TRANS/WP.29/937  
30 July 2003

World Forum for Harmonization of Vehicle Regulations (WP.29)

DRAFT SUPPLEMENT 5 TO THE 03 SERIES  
OF AMENDMENTS TO REGULATION No. 44

(Child restraint systems)

Figure 0 (a)

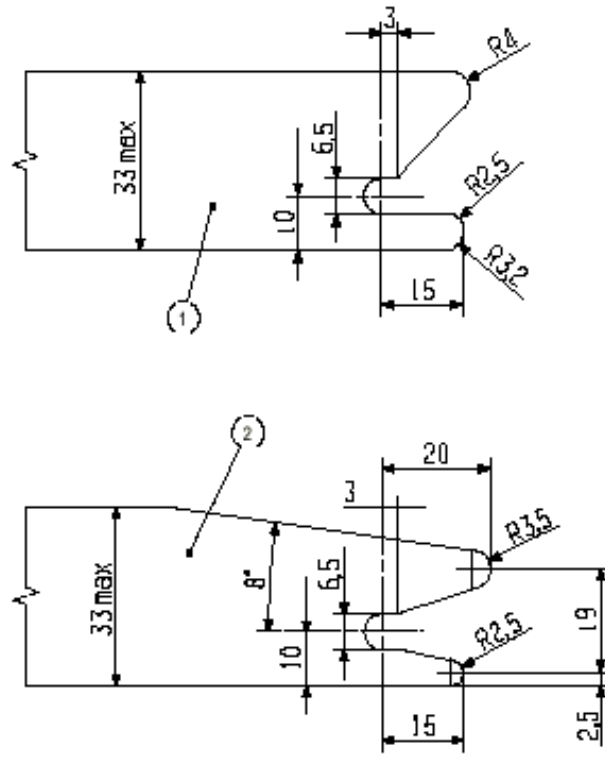
6.3.2. ISOFIX Attachments

6.3.2.1. Type

ISOFIX Attachments may be according to examples shown in figure 0 (a), or other appropriate designs that are part of a rigid mechanism having provision for adjustment, the nature of which is determined by the ISOFIX child restraint system manufacturer.

Figure 0 (b)

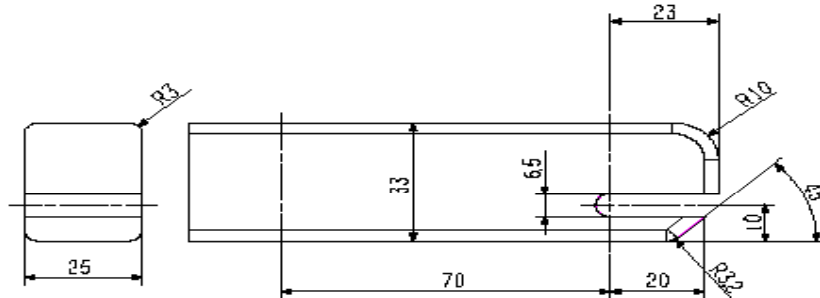
## 6.3.2.2. Dimensions

Dimensions for the portion of the ISOFIX child restraint system attachment that engages the ISOFIX anchorage system must not exceed the maximum dimensions given by the envelope in figure 0 (b)

Figure 0 (c): ISOFIX Top tether connector (hook type) dimensions

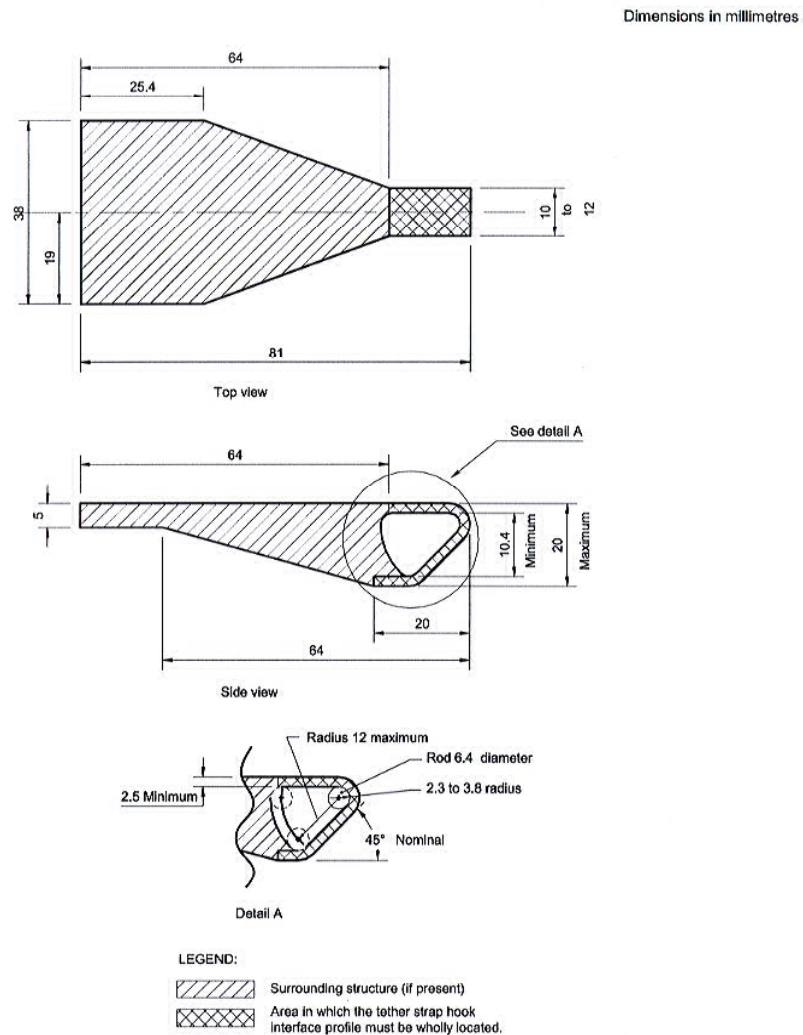
The top tether connector should be ISOFIX top tether hook as shown in figure 0 (c), or similar devices that fit within the envelope given by figure 0 (c).

Engagement dimensions for ISOFIX top tether hooks are shown in figure 0 (c).

Figure 1"

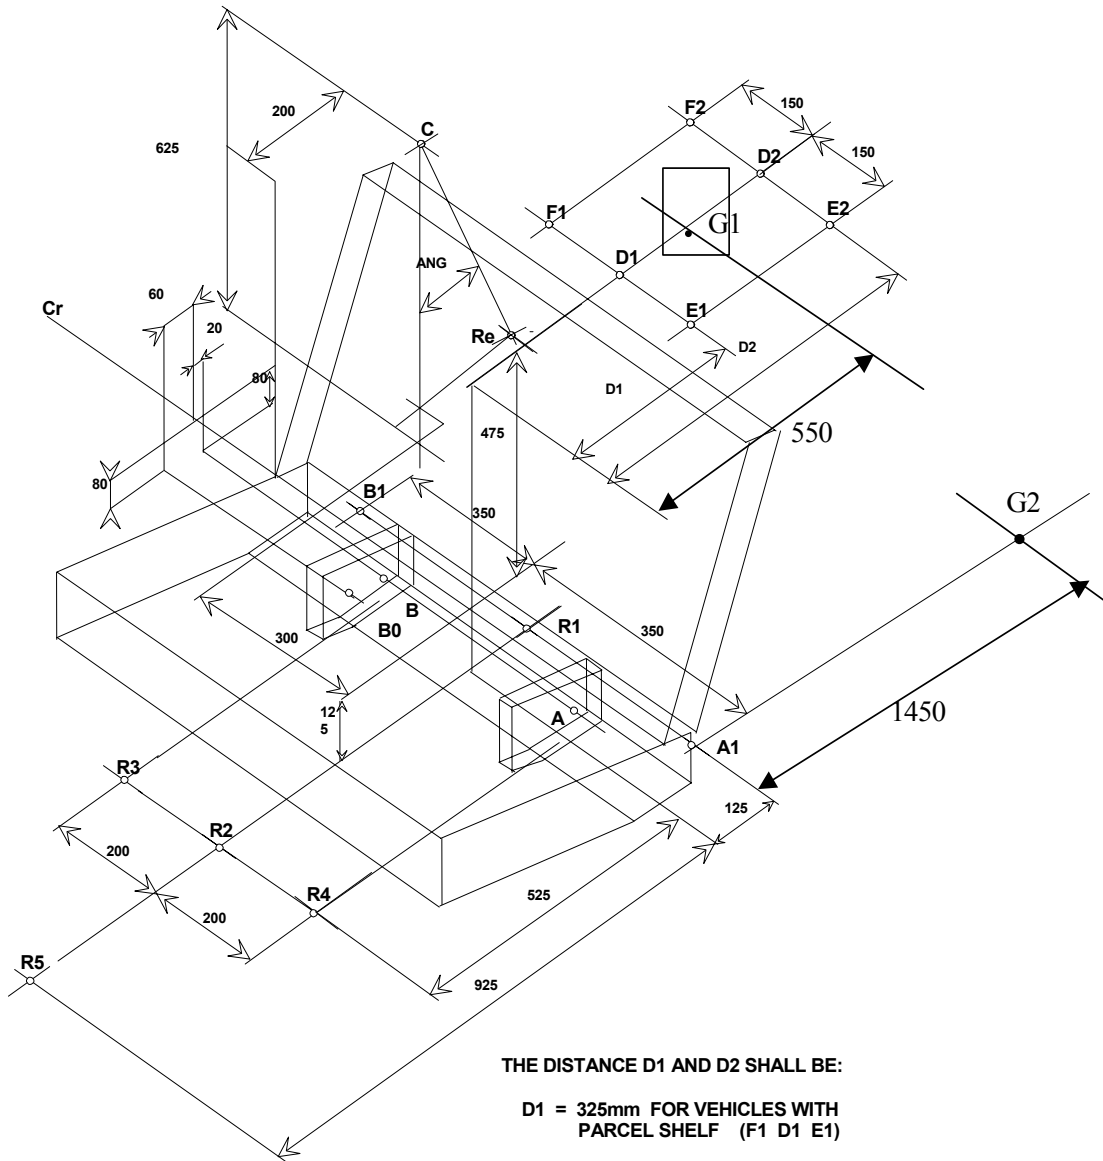
Figure 1, amend to read:

THE DISTANCE D1 AND D2 SHALL BE:

D1 = 325mm FOR VEHICLES WITH  
PARCEL SHELF (F1 D1 E1)

D1 = 1025mm FOR VEHICLES WITH  
FOLDING BACK REAR SEATS  
(ESTATE TYPE) (F2 D2 E2)

DIMENSIONS REFERRING TO Cr  
ARE TOLERANCED WITH:  $\pm 2$  mm  
EXCEPT FOR DISTANCE FLOOR TO Cr  $\pm 10$ mm

DISTANCE C - Re = 550mm  
ANGLE "ANG" = 30° MAXIMUM

Figure 2

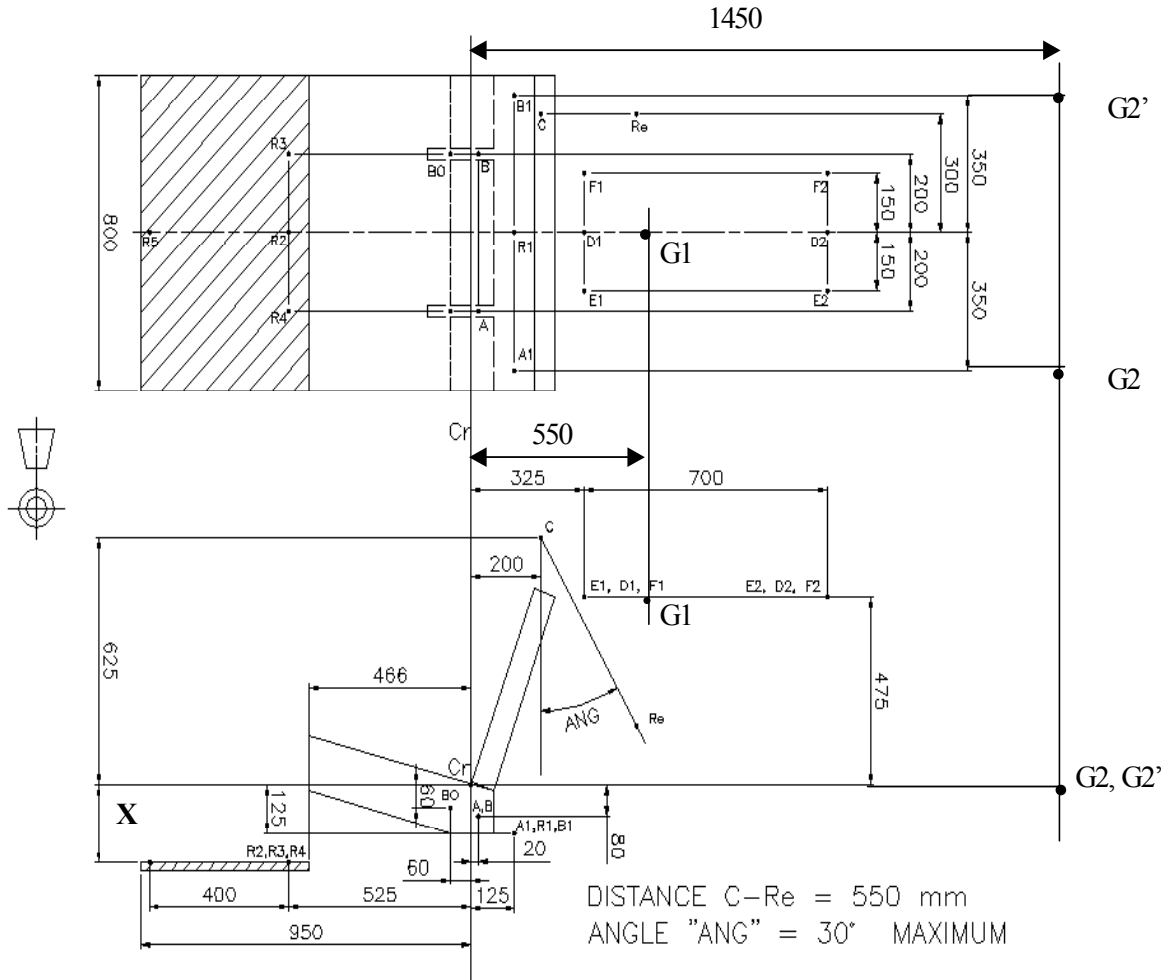
Figure 2, amend to read:

FLOOR AREA IS HATCHED

Figure 3 “

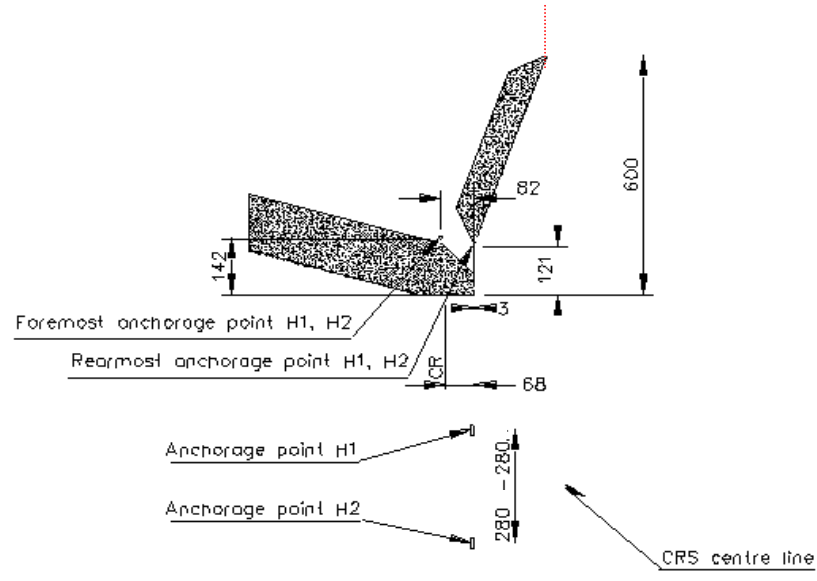
Insert a new figure 3, to read:

Anchorage points H1 & H2 – 6 mm ± 0.1 mm

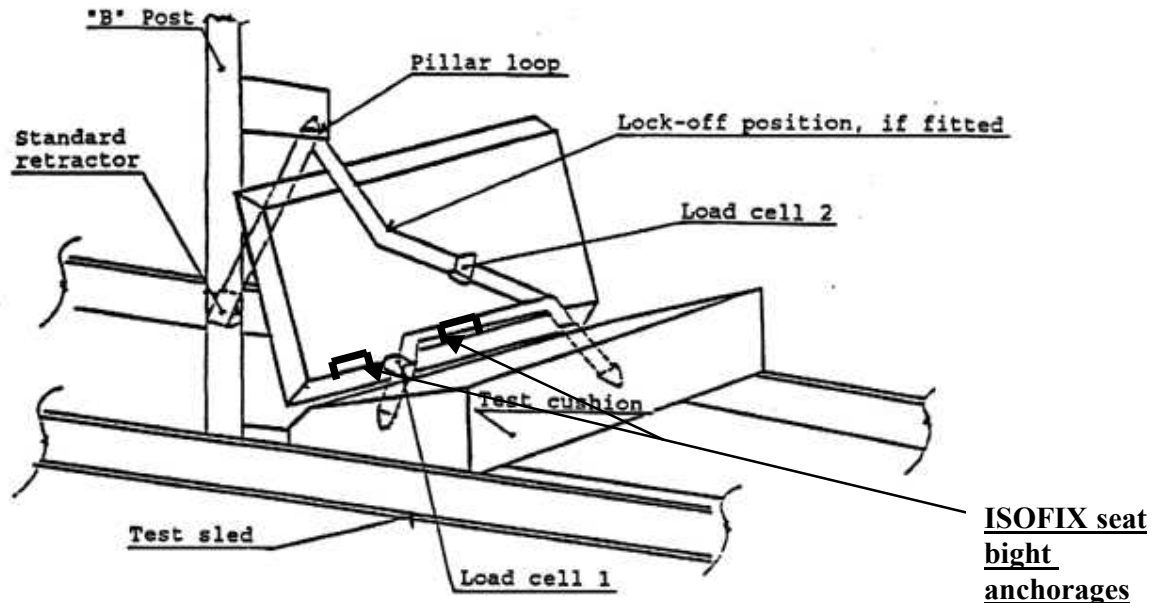
Annex 21,

The figure, amend to read:
